MEMORANDUM

TO: Planning and Zoning Commission
CC: Becky McKay, Engineering Solutions
FROM: Joseph Dodson, Current Associate Planner
RE: Centerville Subdivision AZ, PP (H-2021-0046)

B. Revised Preliminary Plat

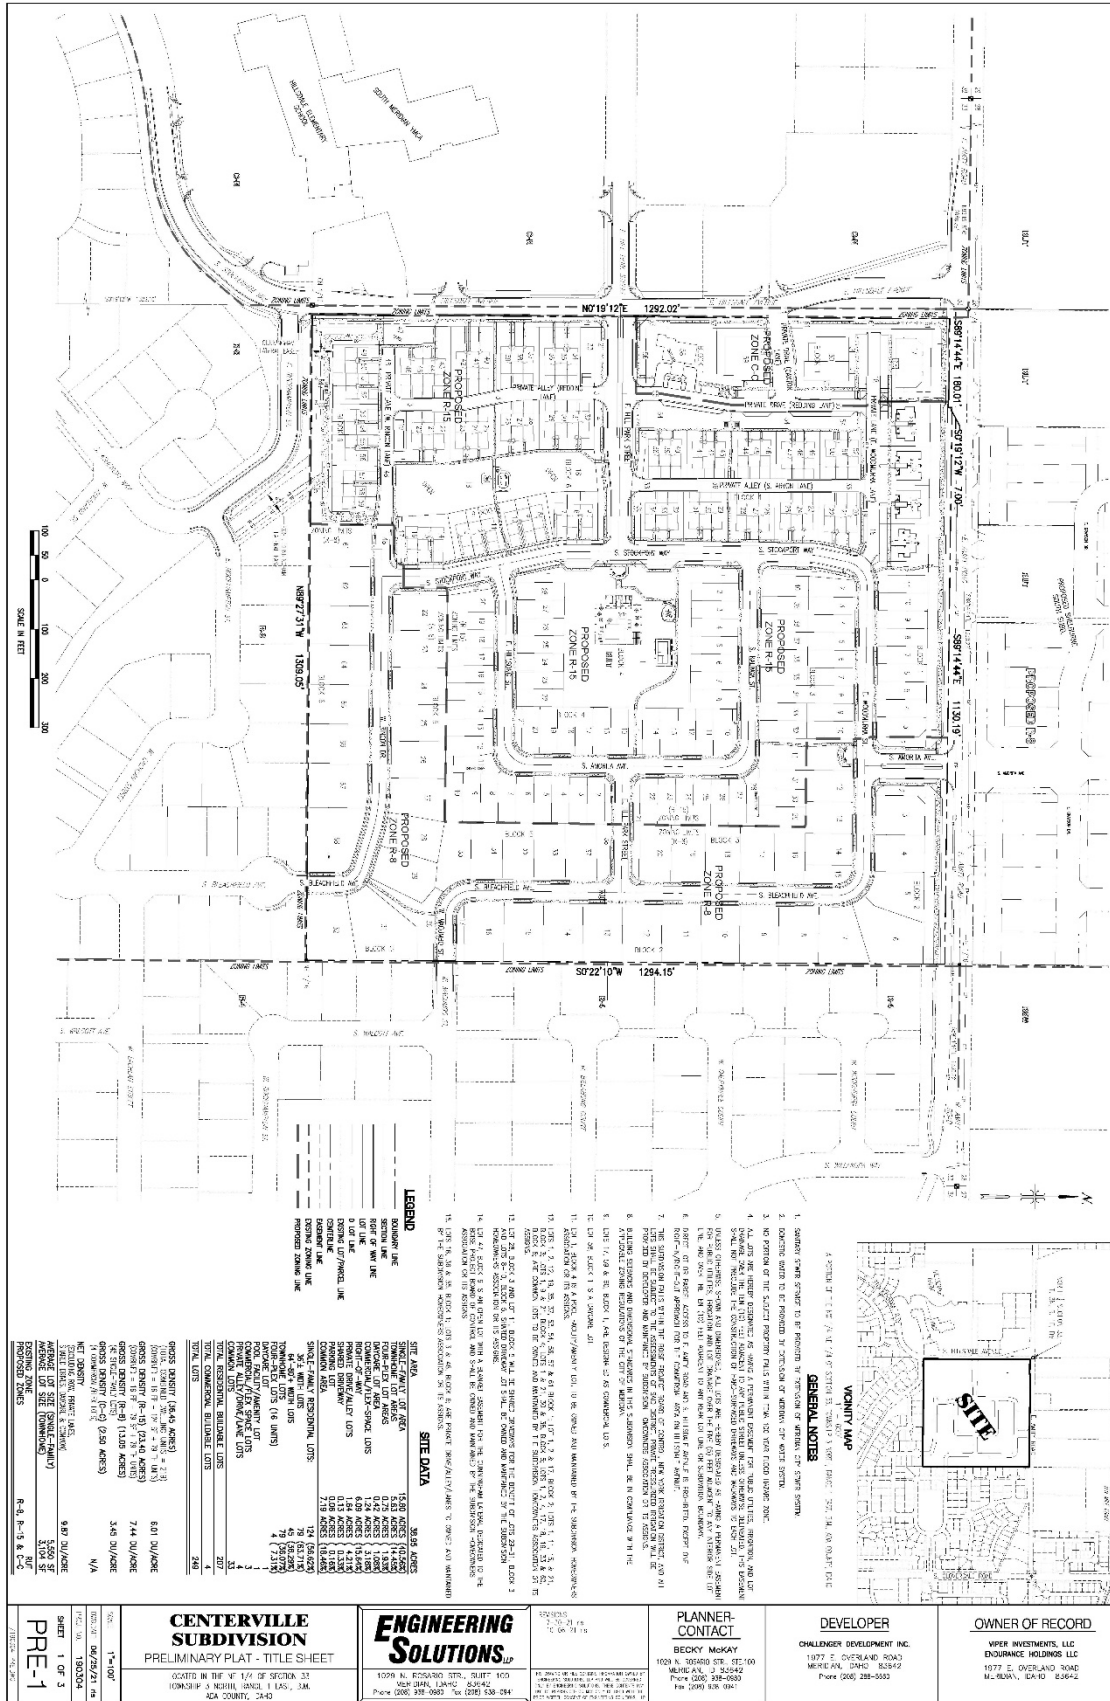
- The Applicant has provided revised legal descriptions and exhibits for the change in zoning boundaries proposed.
- Applicant is now requesting 2.5 acres of C-C zoning with their annexation application to accommodate four (4) commercial building lots instead of the original one (1) daycare lot proposed. The revised plat still shows the daycare use which Staff appreciates. The other commercial buildings are proposed to be located north of the daycare lot and along Hillsdale, nearby the existing commercial on the west side of Hillsdale. According to the revised narrative, the intended uses for the additional commercial lots is flex space (combination of office, retail, and warehousing within one building).

- The C-C zoning district requires a 25-foot landscape buffer between it and any residential use. According to the revised preliminary plat, this requirement is met with adequate landscaping on the east side of each building. Furthermore, there is a private street and landscaping separating three (3) of the proposed commercial buildings from the townhome lots to the east.

- Applicant is also proposing a new right-in/right-out access to Hillsdale Avenue for additional access to the commercial lots. Its location is in alignment with an existing commercial access on the west side of Hillsdale so ACHD has approved this additional street connection.

- With the removal of the apartment buildings, the Applicant replaced that area of the site with more townhome units and replaced the multi-family drive aisles with 28-foot wide private streets and more open space that the townhome units front on. The new private streets are functioning as alleys for a majority of the townhome units and as the access for the commercial lots.

- Private Street standards outlined in UDC 11-3F-4 require a minimum 24-foot wide driving surface so the proposed 28-foot wide private streets exceed code requirements. In addition, sidewalks are not required with private streets but the Applicant is proposing detached sidewalks throughout the townhome area for access to the units.

- Modify A.1e. – Per the submitted and revised preliminary plat, Lot ~~3058~~, Block 1 shall be reserved for a future daycare facility and Lots 17, 59, & 60, Block 1 shall be reserved for future commercial uses.
